Access Compliance Report

Public Rights-of-Way

| Intersection ID: 45542 | Main Street: HARRIER_RD | Cross Street: GOSHAWK_LN | Location: E |
| ADA ID: AC80865B5915 | Ramp Type: PerpDiag | Initial Pass/Fail: Fail | Overall Compliance: No |

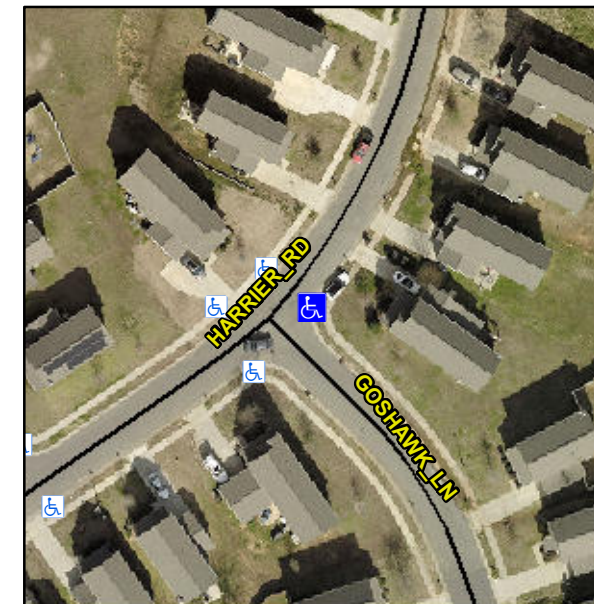
Not Found, R304.5.1, R304.5.3

| Compliance | Description | Data | Compliance | Description | Data |
|------------|-----------------------|------|------------|-----------------------------|-------|
| N/A | Ramp Length (in) | 48.0 | Yes | Ramp Slope (%) | 7.6 |
| No | Ramp Width (in) | 47.5 | No | Ramp XSlope (%) | 5.1 |

Remove & Replace Curb Ramp With Two New Directional Ramps or Equivalent.
